# UNITED STATES PATENT AND TRADEMARK OFFICE

APPLICATION NO.	FILING DATE	FIRST NAMED INVENTOR	ATTORNEY DOCKET NO.	CONFIRMATION NO.
10/618,689	07/09/2003	Robert L. Doubler	2131.000019	8552
43541	7590	04/19/2006	EXAMINER REESE, DAVID C	
FAEGRE & BENSON ATTN: PATENT DOCKETING 2200 WELLS FARGO CENTER 90 SOUTH 7TH STREET MINNEAPOLIS, MN 55402-3901			ART UNIT 3677	PAPER NUMBER

## Office Action Summary

## **DETAILED ACTION**

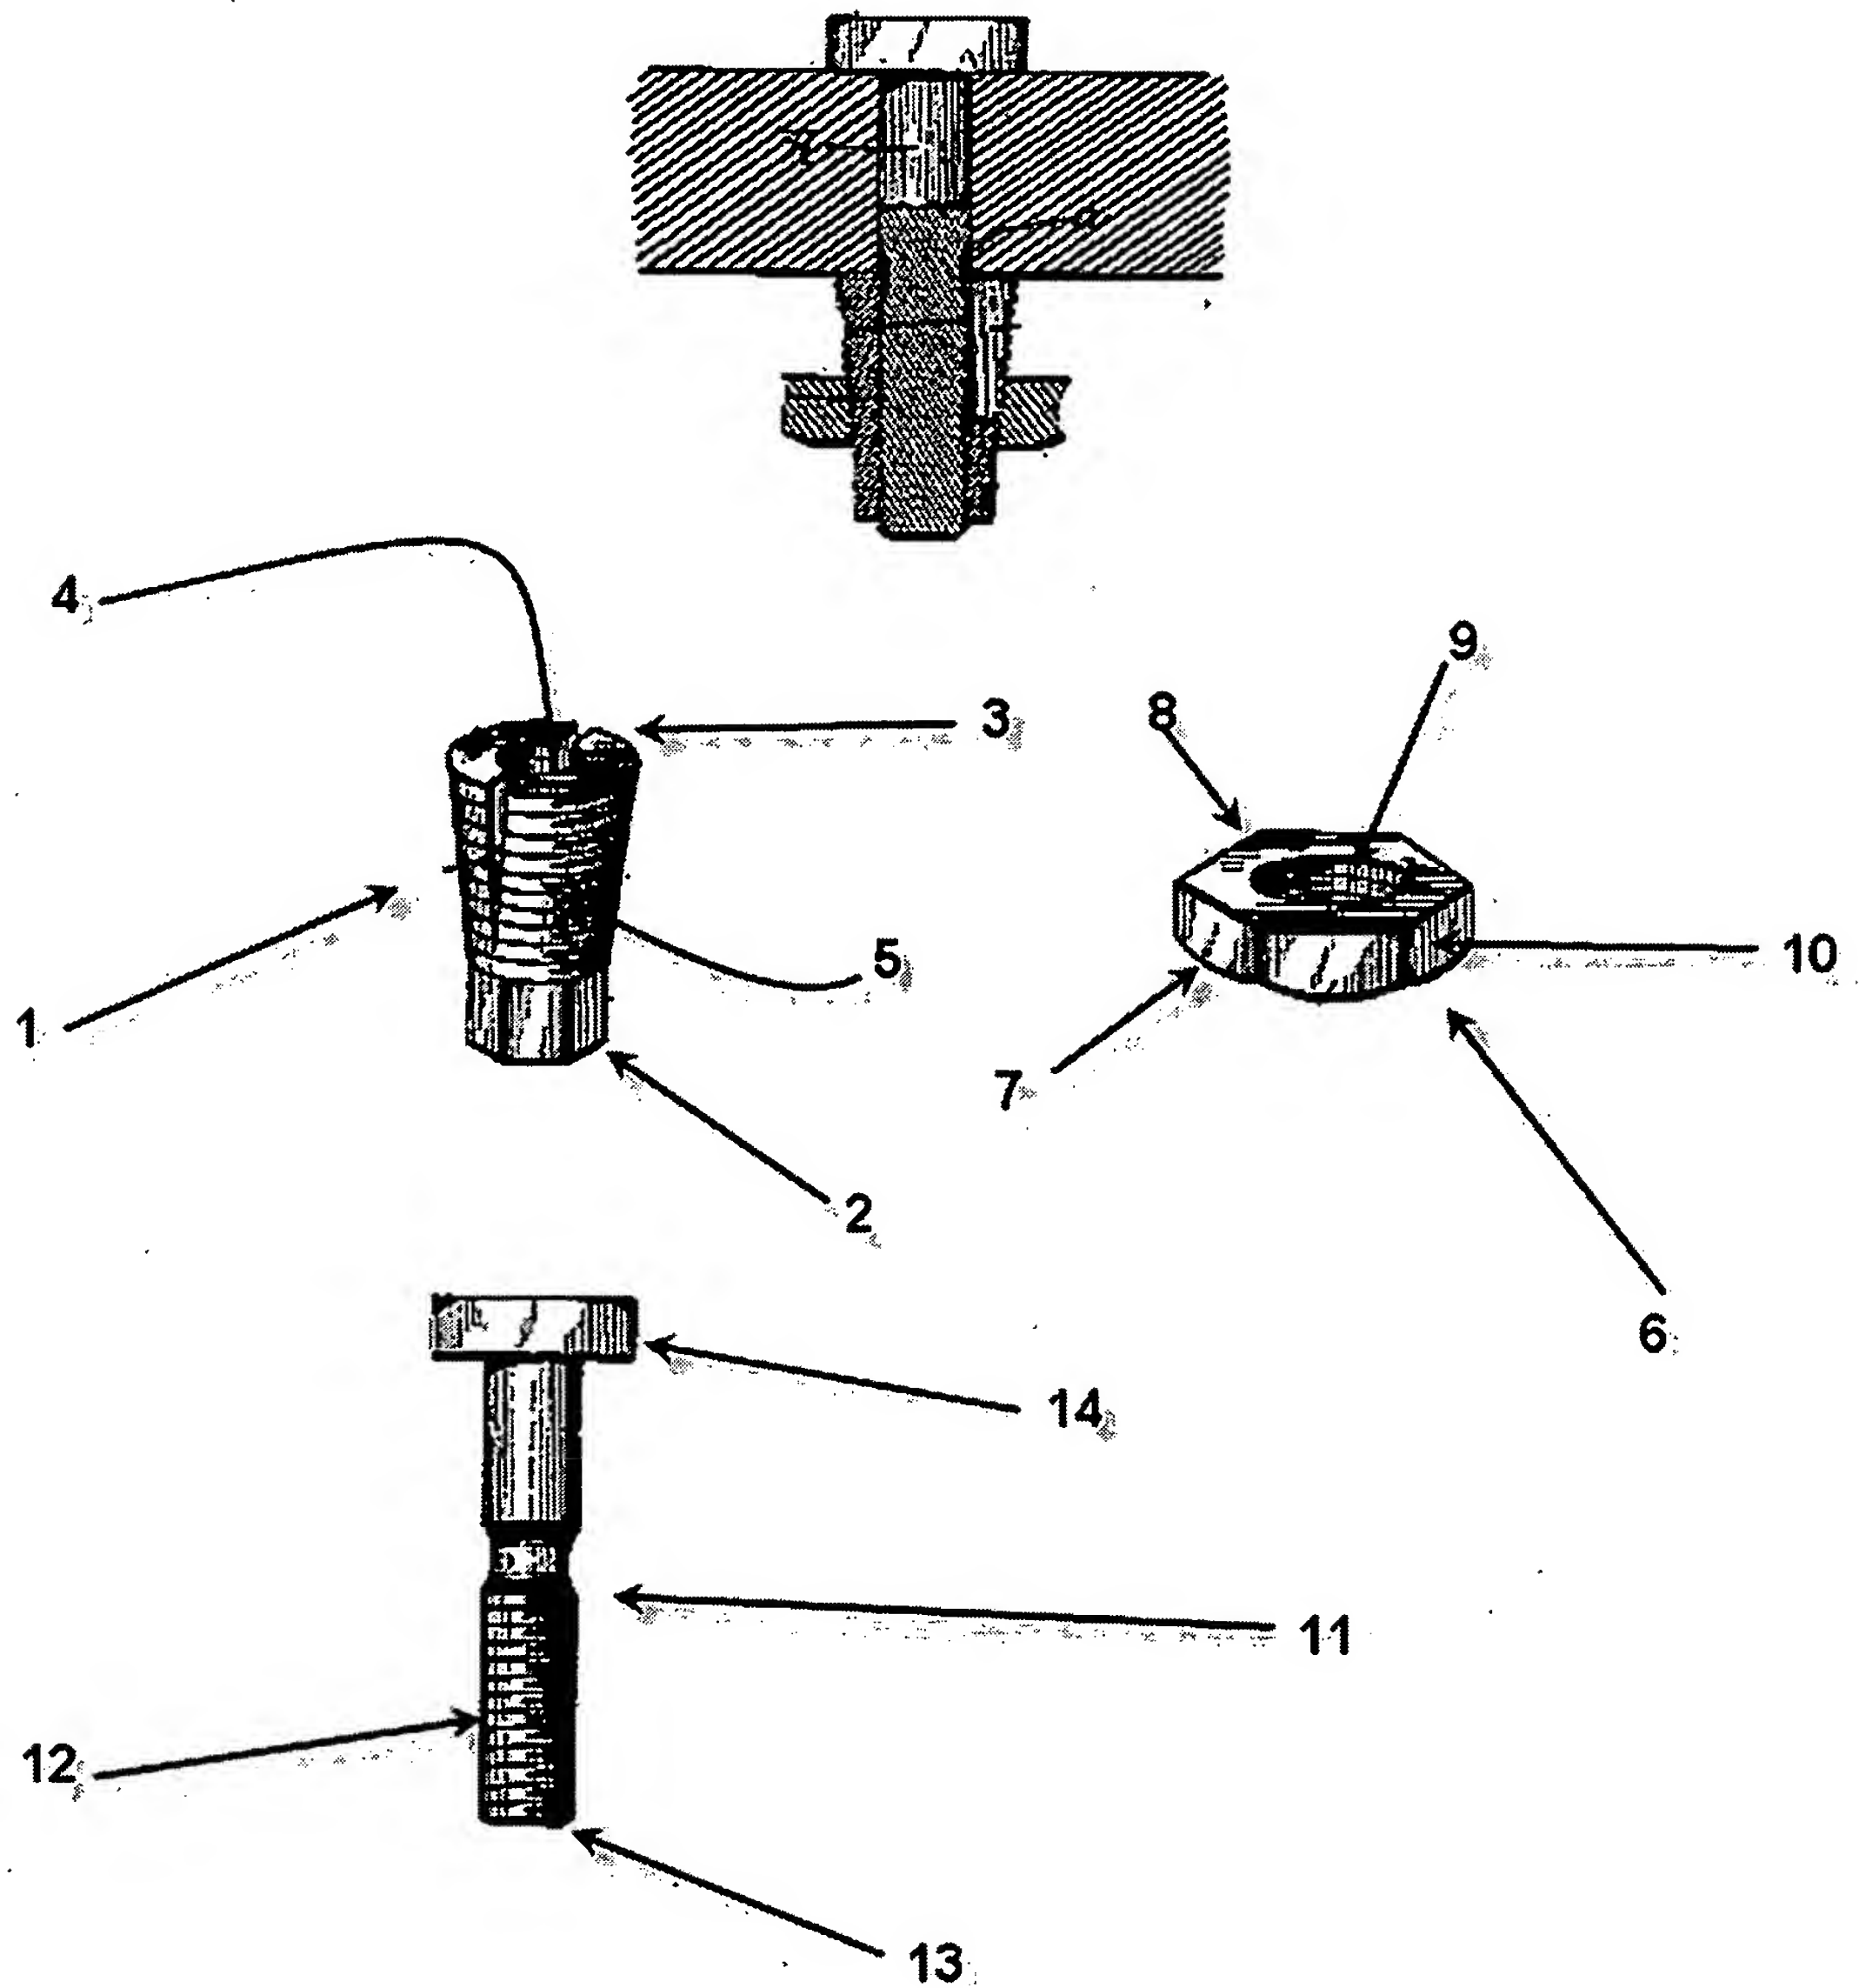
[6] Claims 1-5, 10, and 17 are rejected under 35 U.S.C. 102(b) as clearly anticipated by Archer, US-590,294, because the invention was patented or described in a printed publication in this or a foreign country, or in public use or on sale in this country more than one (1) year prior to the application for patent in the United States.

As for Claim 1, Archer discloses a linear fastener system (see figures below) comprising:  
a collet member (1) having a base end (2), a top end (3), an inner engaging surface (4),  
and an outer ribbed surface (5) positioned about a central axis;

a compression ring member (6) having a base end (7), a front end (8), an inner ribbed surface (9), and an outer surface (10) positioned about a central axis;

said inner ribbed surface (9) of said compression ring member (6) being constructed and arranged for coaxial alignment and overlapping engagement with respect to said outer ribbed surface (5) of said collet member (1), said compression ring member (6) linearly traversable with respect to said outer ribbed surface (5) of said collet member (1) between a first release position and a second engaged position, wherein said engaged position results in said ribbed surfaces (9) compressing said collet member (1) and tensilely loading said compression ring (6) member to engage a shank member (11) having an outer gripping surface (12), and wherein said release position results in expansion of said collet member (1) thereby releasing said outer gripping surface (12) of said shank member (11).

Re: Claim 2, including a shank member (11) having an outer gripping surface (12), a first end (14), and a second end (13).

Re: Claim 3, wherein said ribbed outer surface (5) of said collet member (1) includes at least one outwardly and circumferentially extending rib (5), each said rib including a first ramp surface to facilitate coaxially aligned linear overlapping movement of said compression ring (6) in relation to said collet member (1) for engagement thereof, and a second ramp surface to facilitate linear removal of said compression ring (6) from said collet member (1).

Re: Claim 4, wherein said inner engaging surface (4) of said collet member (1) is constructed and arranged with a conjugate shape in relation to said outer gripping surface (12) of said shank member (11).

Re: Claim 5, wherein said inner engaging surface (4) of said collet member (1) constructed and arranged with internal threads (4).

Re: Claim 10, wherein said first end (14) of said shank member (11) includes a tensioning means (14), said tensioning means (14) being constructed and arranged to allow said shank member (11) to be tensilely loaded prior to linear traversal of said compression ring member (6) into said engagement position with respect to said collet member (1).

As for Claim 17, wherein said outer ribbed surface (5) of said collet member (1) and said inner ribbed surface (9) of said compression ring member (6) are constructed and arranged to maintain an axially aligned interfitting relationship in said release position (with compression member (6) near the bottom of said collet member, (1).

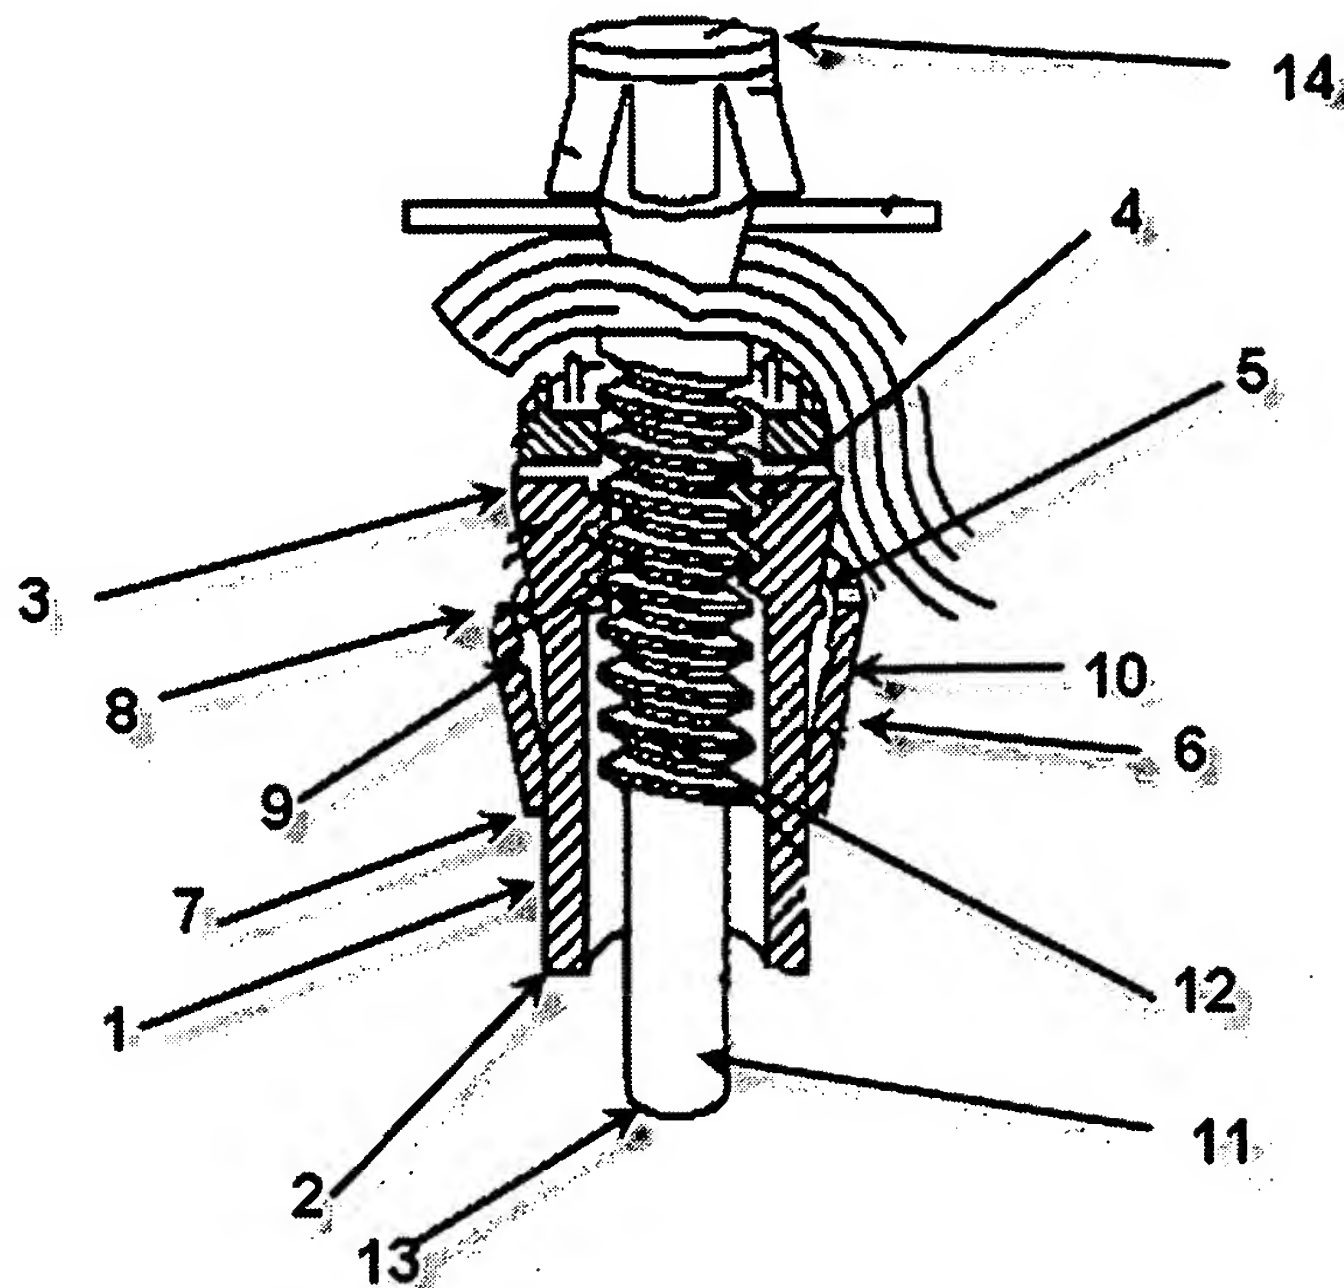
[7] Claims 1-5, 10, 13, and 17 are rejected under 35 U.S.C. 102(b) as clearly anticipated by Freedland et al., US-6,162,234, because the invention was patented or described in a printed publication in this or a foreign country, or in public use or on sale in this country more than one (1) year prior to the application for patent in the United States.

As for Claim 1, Freedland et al. discloses a linear fastener system (see figure below) comprising:

a collet member (1) having a base end (2), a top end (3), an inner engaging surface (4), and an outer ribbed surface (5) positioned about a central axis;

a compression ring member (6) having a base end (7), a front end (8), an inner ribbed surface (9), and an outer surface (10) positioned about a central axis;

said inner ribbed surface (9) of said compression ring member (6) being constructed and arranged for coaxial alignment and overlapping engagement with respect to said outer ribbed surface (5) of said collet member (1), said compression ring member (6) linearly traversable with respect to said outer ribbed surface (5) of said collet member (1) between a first release position and a second engaged position, wherein said engaged position results in said ribbed surfaces (9) compressing said collet member (1) and tensilely loading said compression ring (6) member to engage a shank member (11) having an outer gripping surface (12), and wherein said release position results in expansion of said collet member (1) thereby releasing said outer gripping surface (12) of said shank member (11).

Re: Claim 2, including a shank member (11) having an outer gripping surface (12), a first end (14), and a second end (13).

Re: Claim 3, wherein said ribbed outer surface (5) of said collet member (1) includes at least one outwardly and circumferentially extending rib (5), each said rib including a first ramp surface to facilitate coaxially aligned linear overlapping movement of said compression ring (6) in relation to said collet member (1) for engagement thereof, and a second ramp surface to facilitate linear removal of said compression ring (6) from said collet member (1).

Re: Claim 4, wherein said inner engaging surface (4) of said collet member (1) is constructed and arranged with a conjugate shape in relation to said outer gripping surface (12) of said shank member (11).

Re: Claim 5, wherein said inner engaging surface (4) of said collet member (1) constructed and arranged with internal threads (4).

Re: Claim 10, wherein said first end (14) of said shank member (11) includes a tensioning means (111E1 in Fig. 43), said tensioning means (111E1 in Fig. 43) being constructed and arranged to allow said shank member (11) to be tensilely loaded (via 6) prior to linear traversal of said compression ring member (6) into said engagement position with respect to said collet member (1).

Re: Claim 13, wherein said shank member tensioning means (111E1 in Fig. 43) includes at least one internal bore (111E1 in Fig. 43) extending inwardly from said first end of said shank member (14 in view of 111E1 in Fig. 43) along the longitudinal centerline of said shank member (11), wherein said at least one internal bore (111E1 in Fig. 43) is constructed and arranged for gripping and placing a tensile load (via 6) on said shank member (11) prior to linear traversal of said compression ring member (6) into said engagement position with respect to said collet member (1).

Re: Claim 17, wherein said outer ribbed surface (5) of said collet member (1) and said inner ribbed surface (9) of said compression ring member (6) are constructed and arranged to maintain an axially aligned interfitting relationship in said release position (with compression member (6) near the bottom of said collet member, (1).

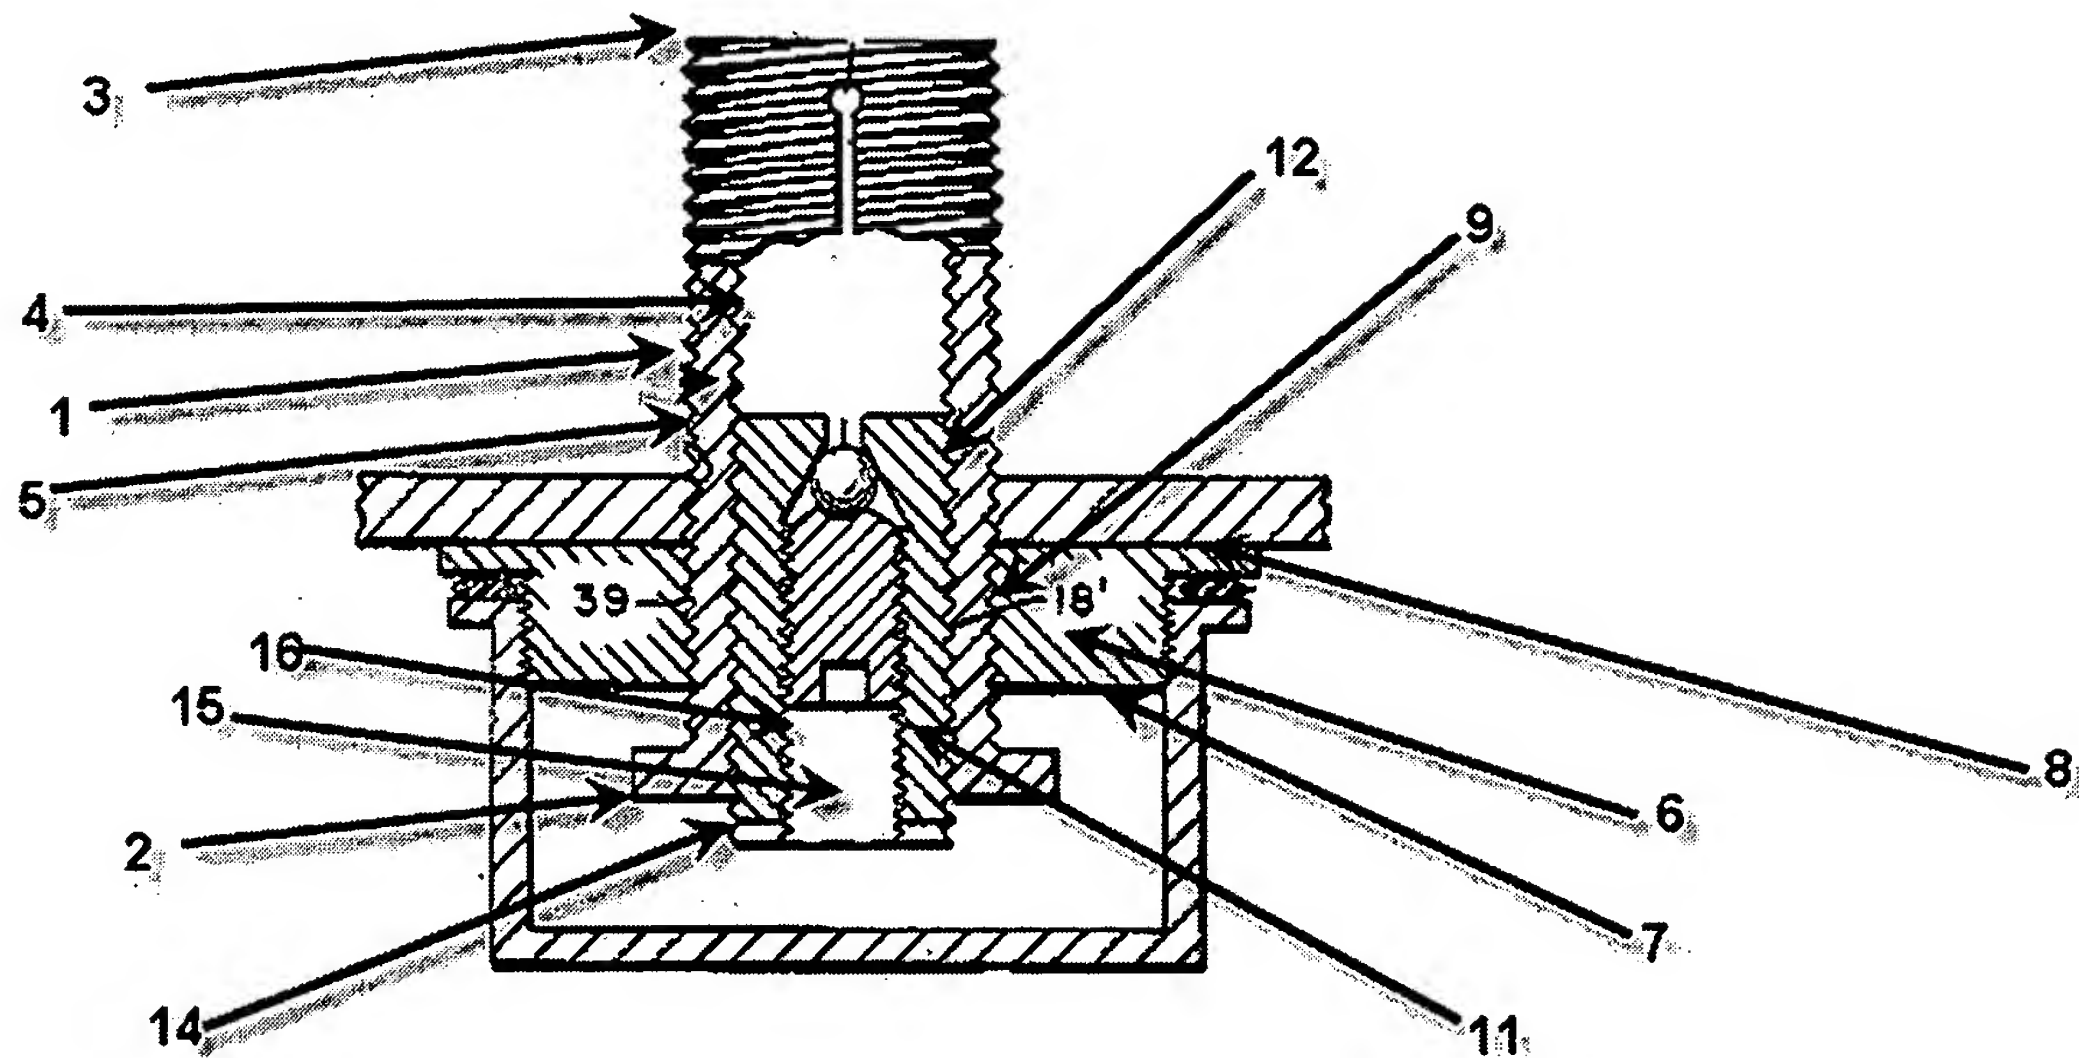
[8] Claims 1-5, 10, 13-14 and 17 are rejected under 35 U.S.C. 102(b) as clearly anticipated by Weller, US-3,618,135, because the invention was patented or described in a printed publication in this or a foreign country, or in public use or on sale in this country more than one (1) year prior to the application for patent in the United States.

As for Claim 1, Weller discloses a linear fastener system (see figure below) comprising:  
a collet member (1) having a base end (2), a top end (3), an inner engaging surface (4),  
and an outer ribbed surface (5) positioned about a central axis;

a compression ring member (6) having a base end (7), a front end (8), an inner ribbed surface (9), and an outer surface (10) positioned about a central axis;

said inner ribbed surface (9) of said compression ring member (6) being constructed and arranged for coaxial alignment and overlapping engagement with respect to said outer ribbed surface (5) of said collet member (1), said compression ring member (6) linearly traversable with respect to said outer ribbed surface (5) of said collet member (1) between a first release position and a second engaged position, wherein said engaged position results in said ribbed surfaces (9) compressing said collet member (1) and tensilely loading said compression ring (6) member to engage a shank member (11) having an outer gripping surface (12), and wherein said release position results in expansion of said collet member (1) thereby releasing said outer gripping surface (12) of said shank member (11).

Re: Claim 2, including a shank member (11) having an outer gripping surface (12), a first end (14), and a second end (13).

Re: Claim 3, wherein said ribbed outer surface (5) of said collet member (1) includes at least one outwardly and circumferentially extending rib (5), each said rib including a first ramp surface to facilitate coaxially aligned linear overlapping movement of said compression ring (6) in relation to said collet member (1) for engagement thereof, and a second ramp surface to facilitate linear removal of said compression ring (6) from said collet member (1).

Re: Claim 4, wherein said inner engaging surface (4) of said collet member (1) is constructed and arranged with a conjugate shape in relation to said outer gripping surface (12) of said shank member (11).

Re: Claim 5, wherein said inner engaging surface (4) of said collet member (1) constructed and arranged with internal threads (4).

Re: Claim 10, wherein said first end (14) of said shank member (11) includes a tensioning means (15-16), said tensioning means (15-16) being constructed and arranged to allow said shank member (11) to be tensilely loaded prior to linear traversal of said compression ring member (6) into said engagement position with respect to said collet member (1).

Re: Claim 13, wherein said shank member tensioning means (15-16) includes at least one internal bore (15) extending inwardly from said first end of said shank member (11) along the longitudinal centerline of said shank member (11), wherein said at least one internal bore (15) is constructed and arranged for gripping and placing a tensile load on said shank member (11) prior to linear traversal of said compression ring member (6) into said engagement position with respect to said collet member (1).

Re: Claim 14, wherein said internal bore (15) includes internal threads (16).

Re: Claim 17, wherein said outer ribbed surface (5) of said collet member (1) and said inner ribbed surface (9) of said compression ring member (6) are constructed and arranged to maintain an axially aligned interfitting relationship in said release position (with compression member (6) near the bottom of said collet member, (1).
